## NAPSEISComment Resource

Northern Virginia Regulatory Section  
NAO 2008-02534 (Lake Anna)

This is in reference to your request for Corps' comments for the "Supplemental Environmental Impact Statement, Combined License (COL) at North Anna Power Station Unit 3" project in Caroline County.

# Virginia Department of Historic Resources Data Sharing System, 03/01/2009

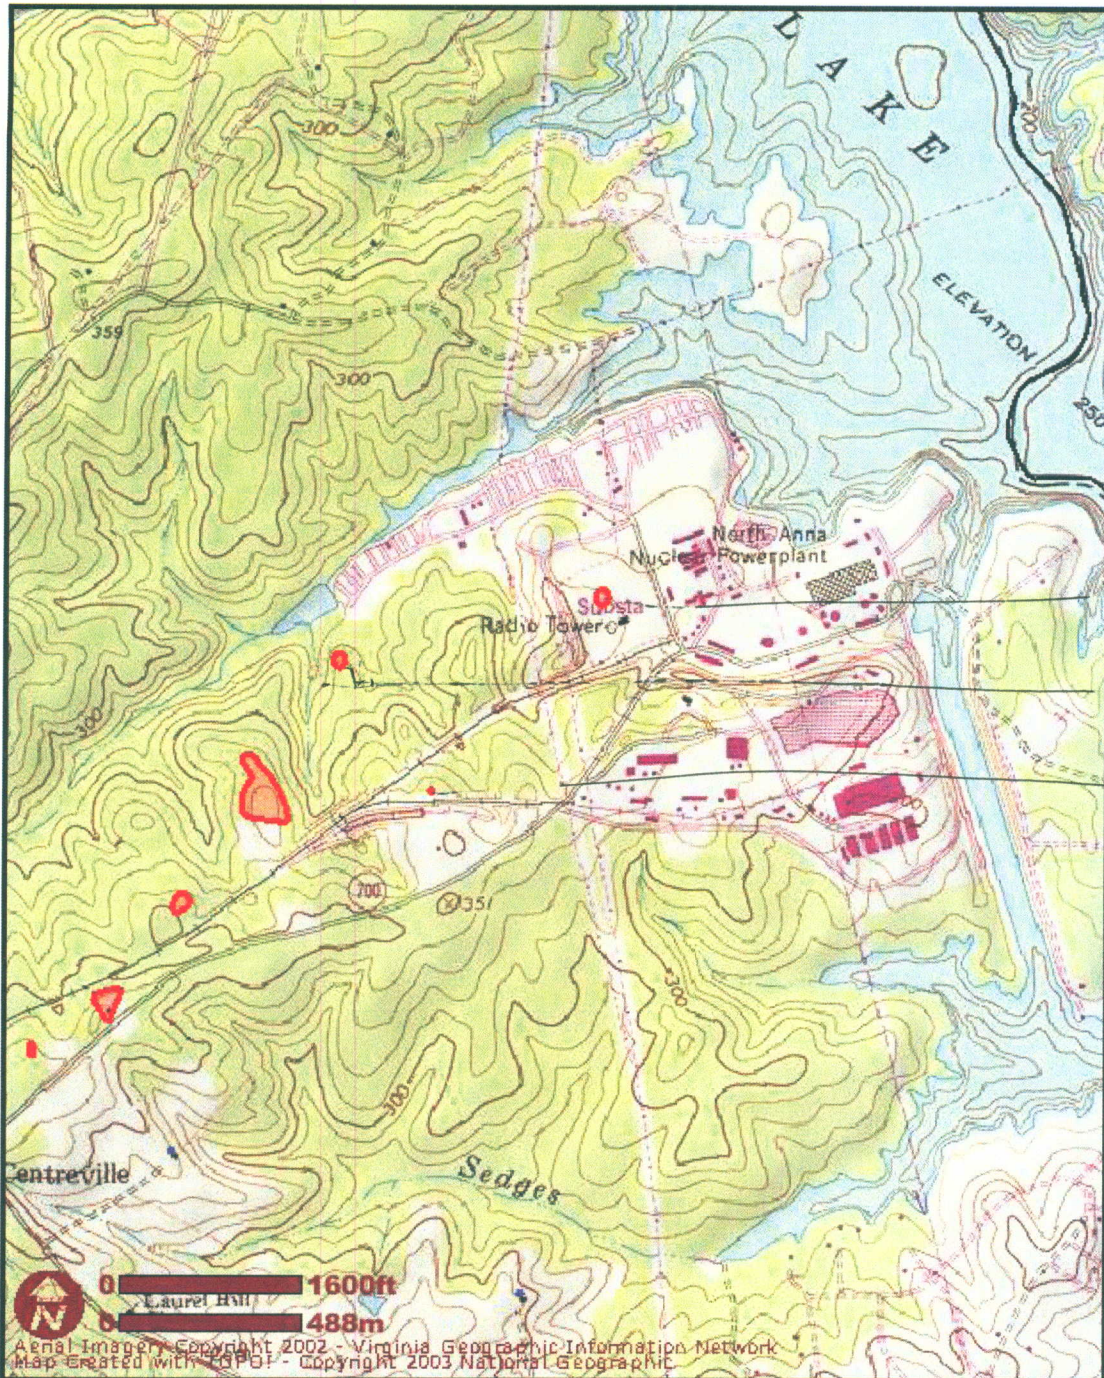
In addition, our review of the Virginia Department of Historical Resources Data Sharing System (VDHR DSS) indicates that the proposed work may affect cultural resources. These resources may be eligible for listing on the National Register of Historic Places (enclosed maps) and may be subject to compliance with Section 106 of the National Historic Preservation Act of 1966.

Pursuant to the above provision, the United States Nuclear Regulatory Commission (USNRC) is hereby designated as the lead federal agency to fulfill the collective Federal responsibilities under Section
